## **ADDENDUM NO. 1**

**Station 34  
Sedgwick County Fire District No. 1  
334 South Main St  
Wichita, Kansas**

February 20, 2013

**STATION 34**  
**SHEET L2**

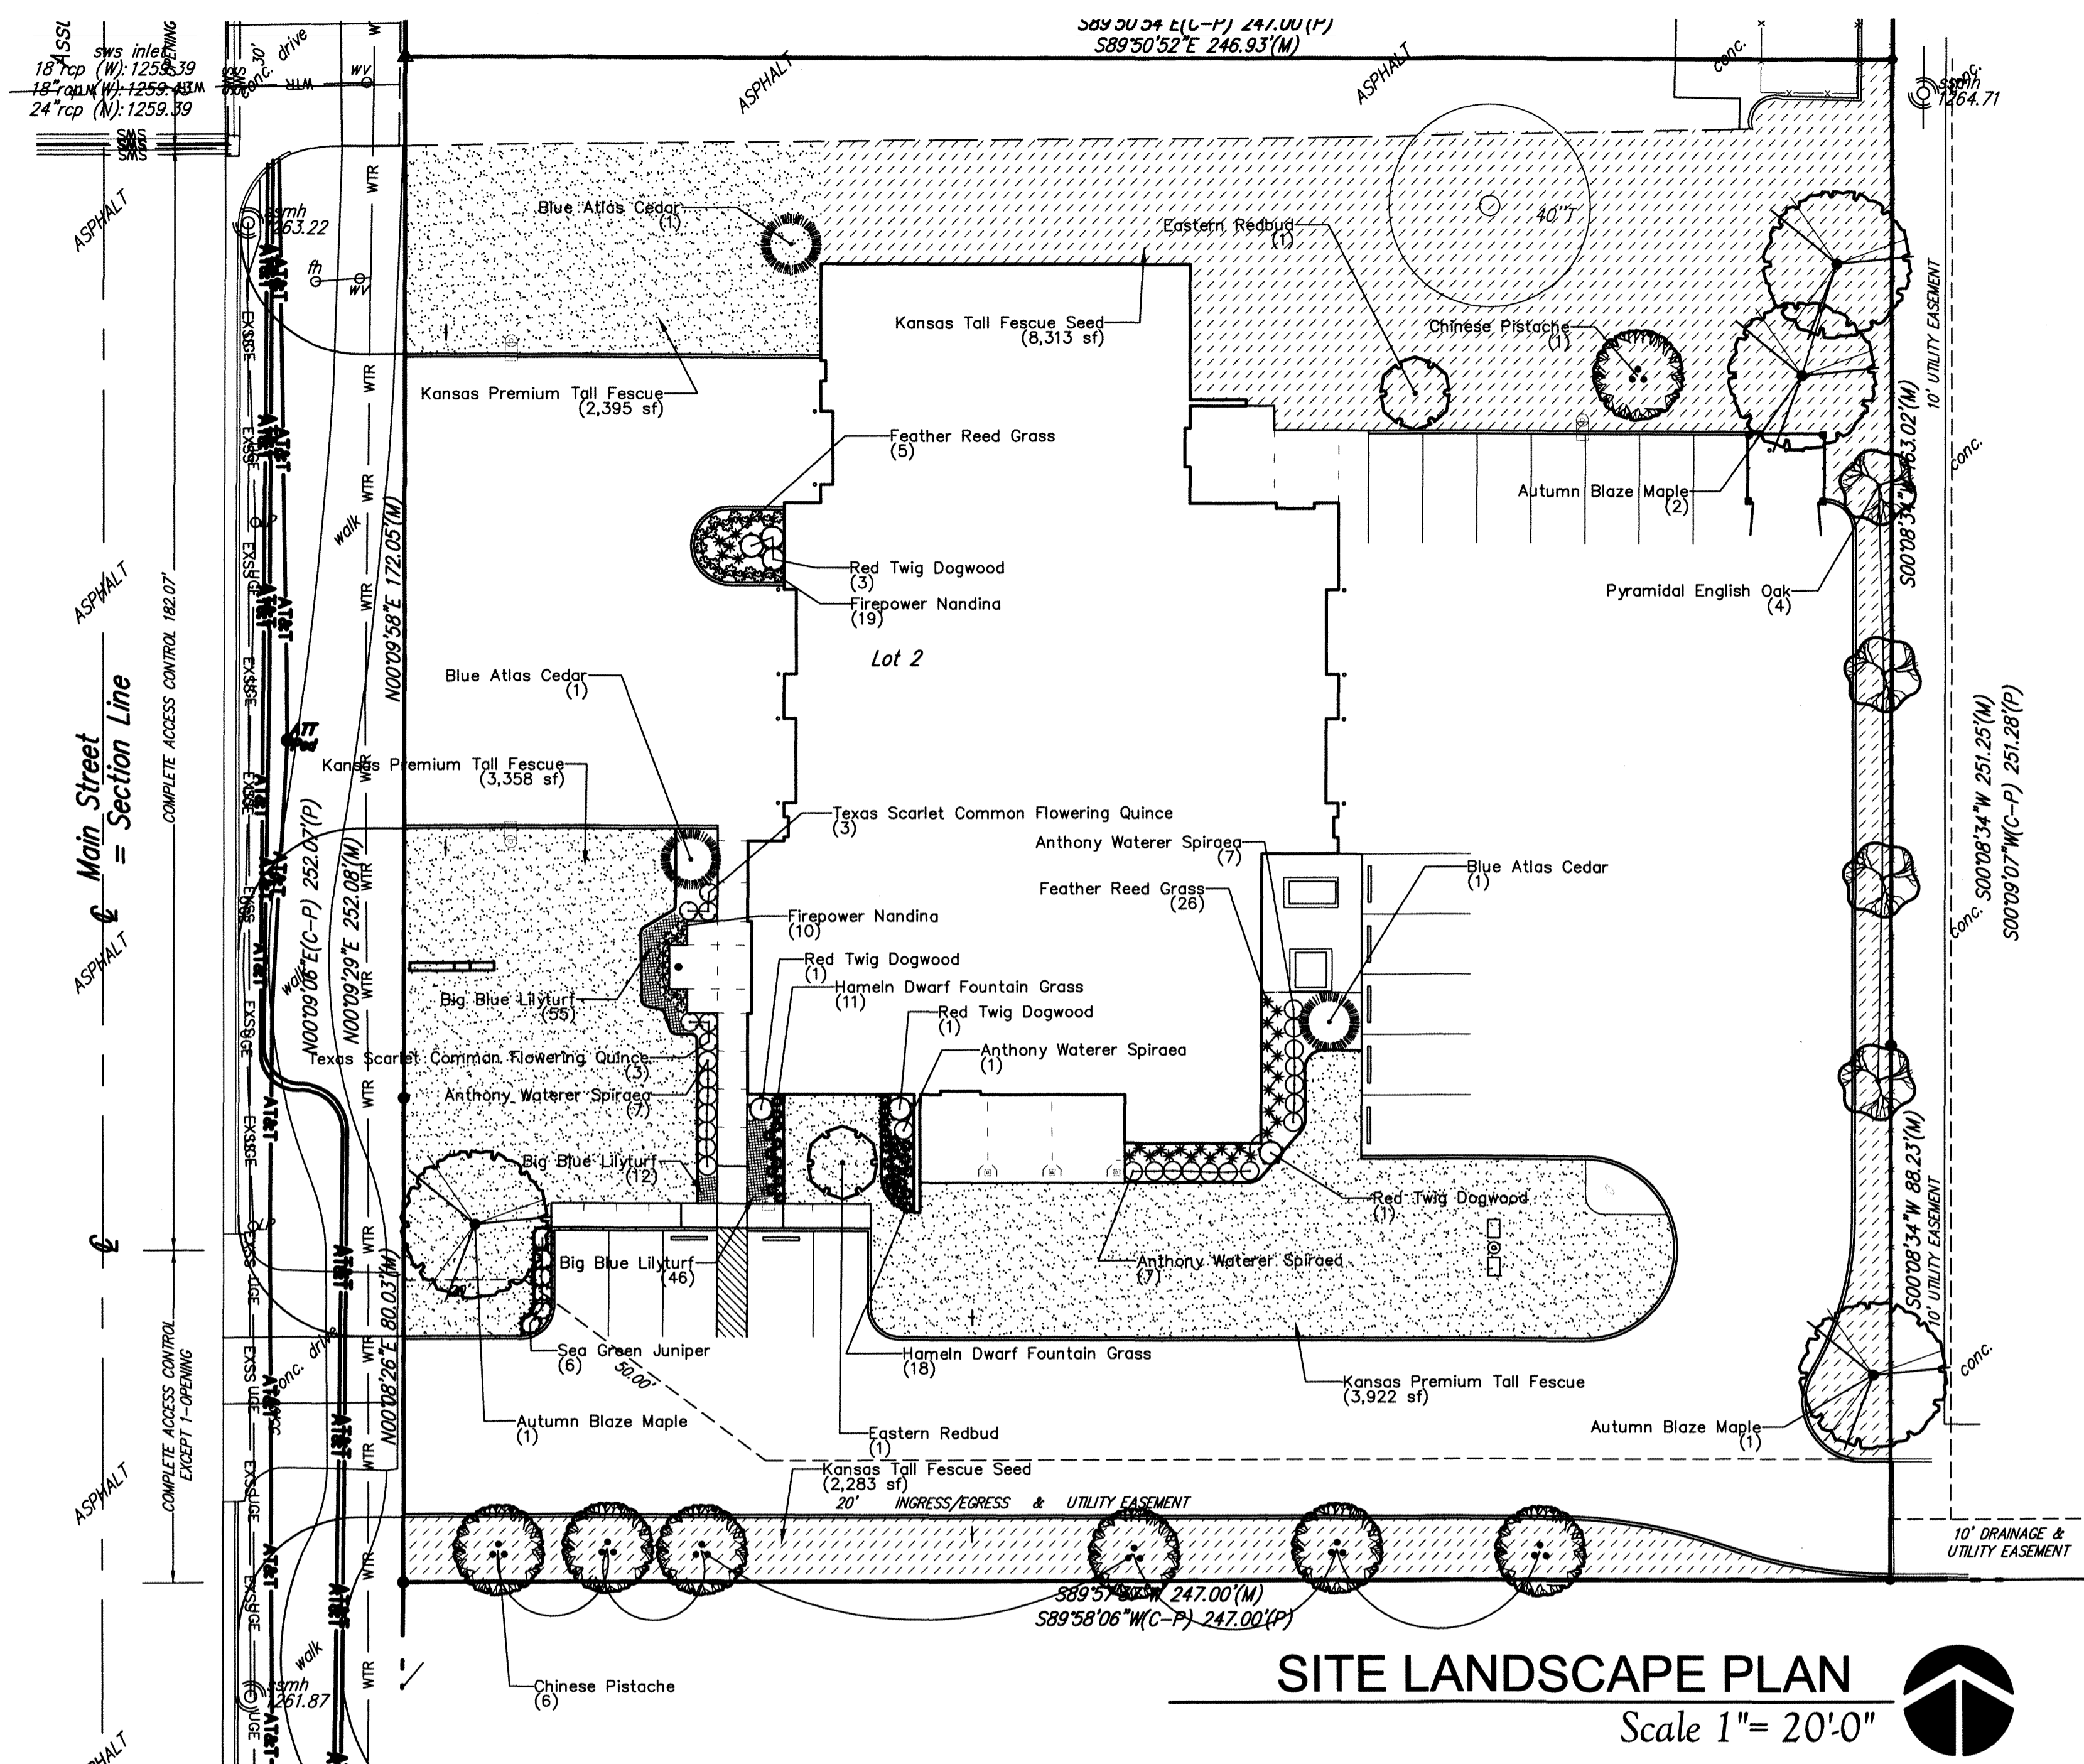
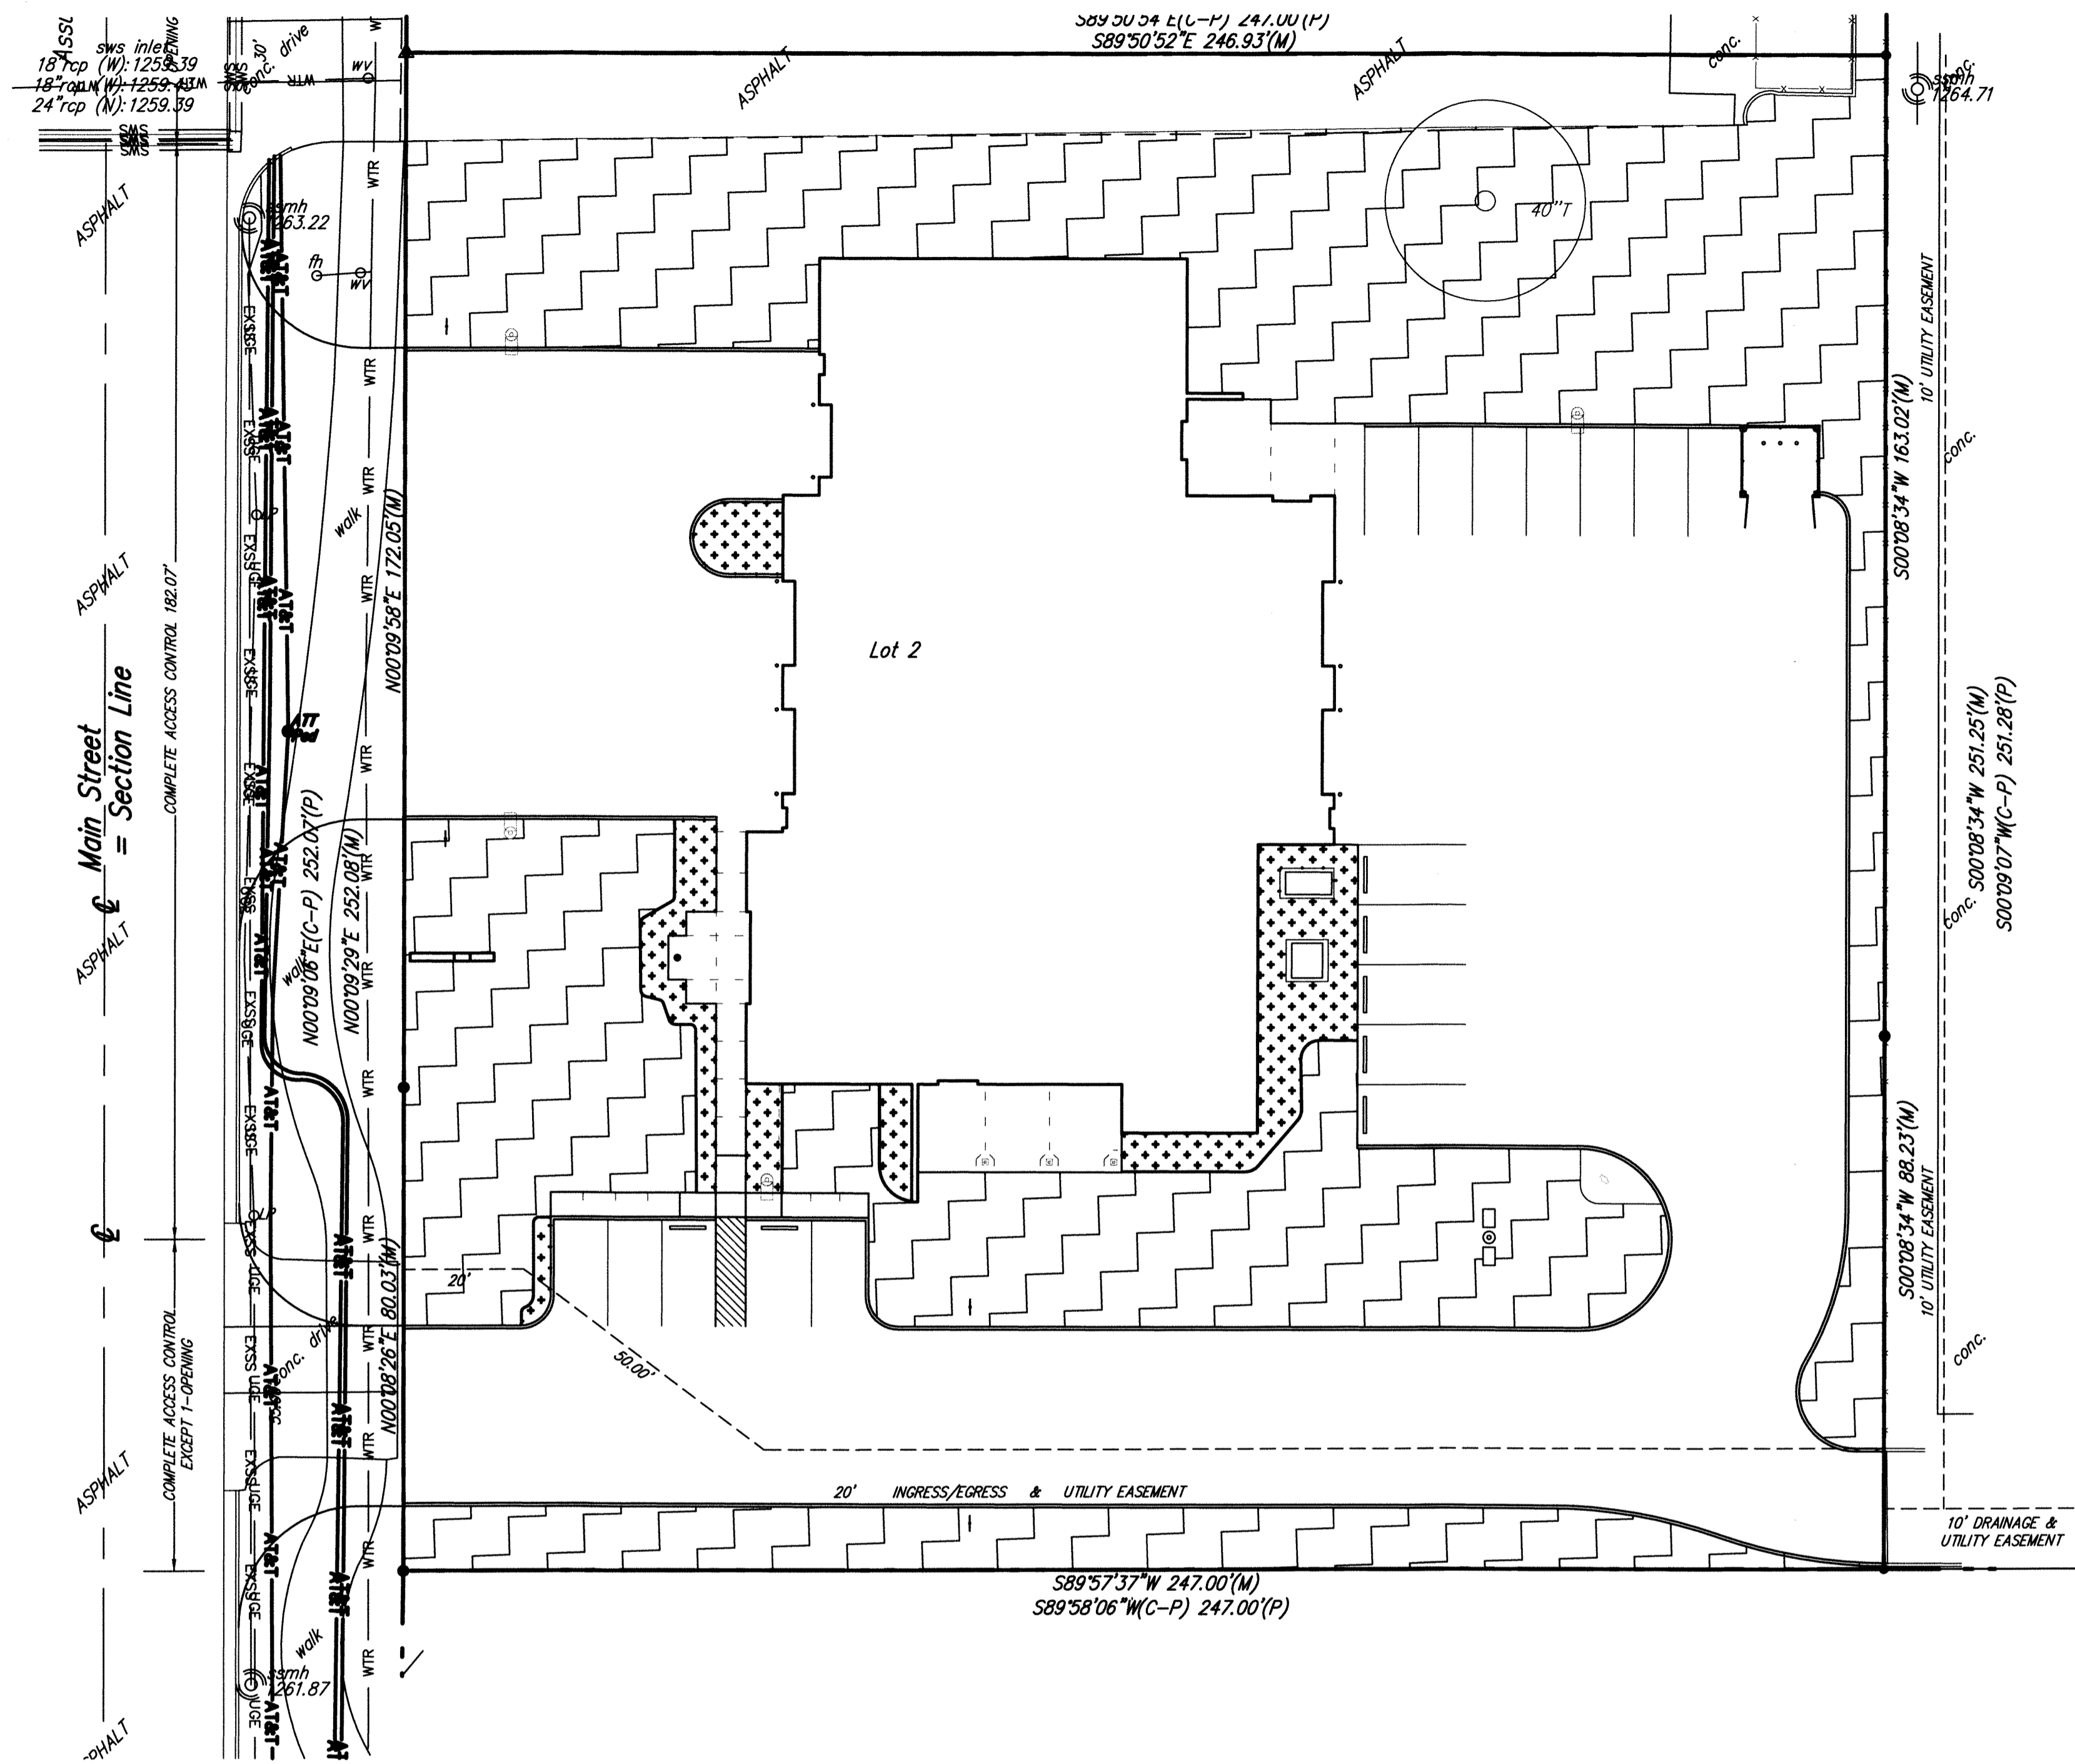
2.	C5	<p>See attached <a href="#">Notice of Intent</a>. Note the attached conditions on the last page of the document.</p>
3.	L1 & L2	<p><i>On sheets L1 &amp; L2 of the plans along the east between the existing fence and concrete pavement running north to south shows what appears to be a storm drainage system with curb inlets and possible area inlets and the line at the north property line heads west to west property line. Sheet C4 Site Utility Plan does not show this, please clarify the intent.</i></p> <p>See enclosed replacement <a href="#">Sheets L1 &amp; L2</a>. These original sheets indicated an old storm sewer design that is not in this contract.</p>

PARTIAL REVISED ROOF FRAMING PLAN

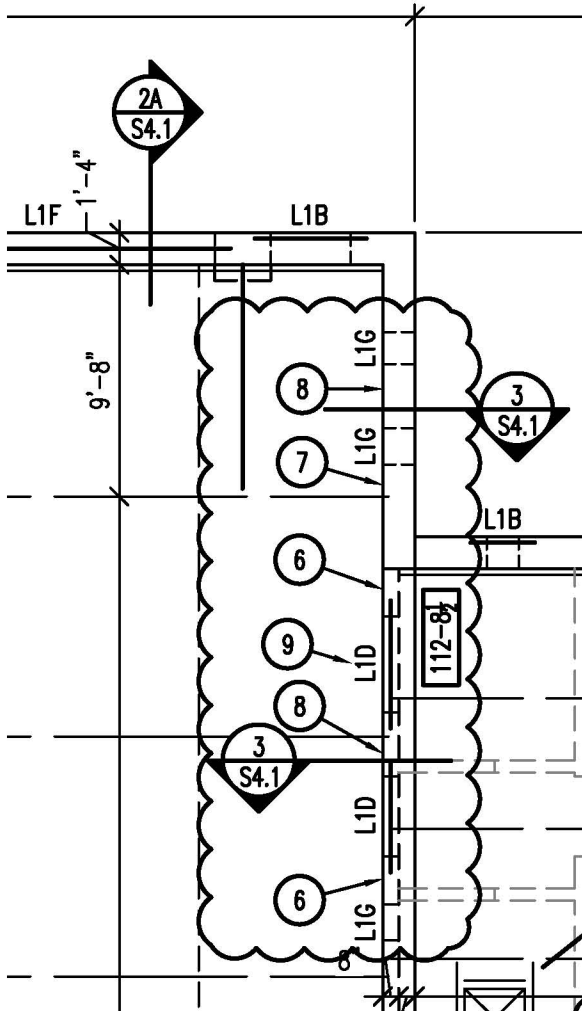
7.	S1.3	<p>See enclosed <a href="#">revision sheet</a> for placement and reinforcing requirements at openings in the south wall of Rm 125.</p>
8.	S2.1	<p>See enclosed <a href="#">revision sheet</a> for revised Lintel Schedule.</p>

16. E2.1 See revision to Sheet S1.3 in this addendum for placement requirements for power panels M1, E1 and the ATS at the south wall of Rm 125 (Apparatus Bay).

REVISED KEYED PLAN NOTES, SHEET S1.3:

- ① Provide Horizontal and Diagonal Joist Bridging as Shown on Framing Plans and per SJI Specifications. Design Roof Joists for a Net Wind Uplift Load of 15 psf. Provide a Single Row of Horizontal Bridging at the First Bottom Chord Panel Point at Each End of Roof Joist.

- ② Mounting Hook, See Architectural for Location and Details. Provide Bracing Above Ceiling per Detail 7-S4.2.
- ③ Metal Deck Type 1, See General Notes.

- ④ HSS8x4x $\frac{1}{4}$ , Elevation Top at 109-4
- ⑤ Brace Top of Masonry Wall per Detail 18-S4.2 Each Side of Roof Opening.
- ⑥ Provide 24" Minimum Between Control Joint at Face of Perpendicular Wall or Door Opening and Electrical Panel Opening as Applicable.

- ⑦ Provide 16" Minimum Between Centerline of Joist Bearing and Jamb of Electrical Panel Opening.
- ⑧ Provide 32" Minimum Between Electrical Panel Opening and Fire Extinguisher Cabinet Opening or Door Opening, as Applicable.

- ⑨ Provide One Lintel L1D Above Two Adjacent Electrical Panels, Maximum Opening 4'-0".

**FIRE DAMPERS REVISION**

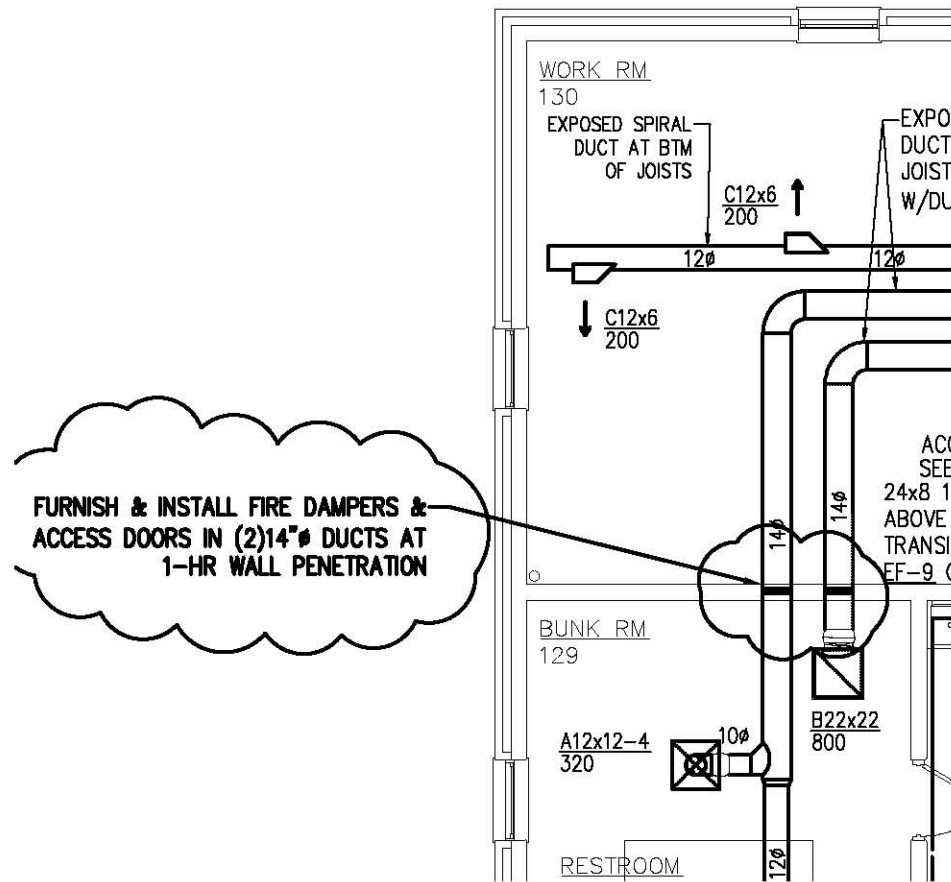
9.	M1.1	<p>Add Fire Dampers in the (2) 14" round duct penetrations of the fire rated wall between Rooms 129 &amp; 130 as shown on the <a href="#">attached drawing</a>. Fire dampers mounted in fire rated wall penetrations shall have 1-1/2 hour Static rating conforming to NFPA Bulletin 90A and shall bear the U.L. Install in accordance with the SMACNA "Fire Damper and Heat Stop Guide for Air Handling Systems." Low Velocity fire dampers shall be factory installed in a 12" long 20 ga. galvanized steel sleeve with factory spot welded seams for attachment to the ductwork. Damper Sleeves shall be secured in the wall with full perimeter 1-1/2", 20 ga. angles, fastened to the sleeve with screws on 12" centers. Provide factory fabricated and insulated access doors and install in the ductwork as required to service the dampers. Access doors shall be a minimum of 12" x 12" except where duct size prevents it in which case they shall be 6" x 12".</p>

**ENGINE EXHAUST SYSTEM REVISION**

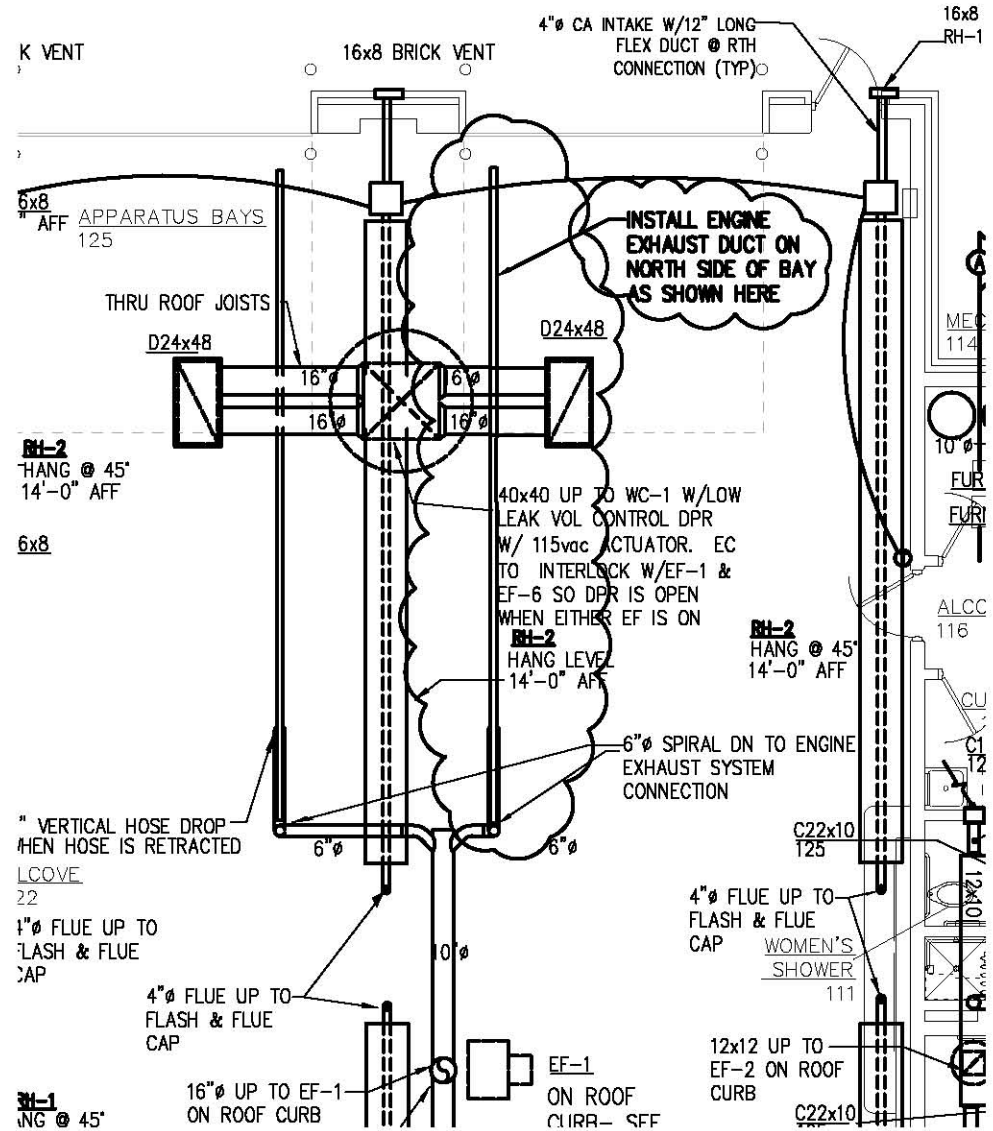
10. M1.1 Revise the location of the engine exhaust system track and associated duct connection as shown on the [attached drawing](#).
11. E1.1 Light Fixture Schedule: Replace Fixture D1 with the following: Delray #ST44228-(2)411-(1)SPF-(1)SRB with (2) 28T5/841 lamps. Coordinate exact placement with architect prior to rough-in.
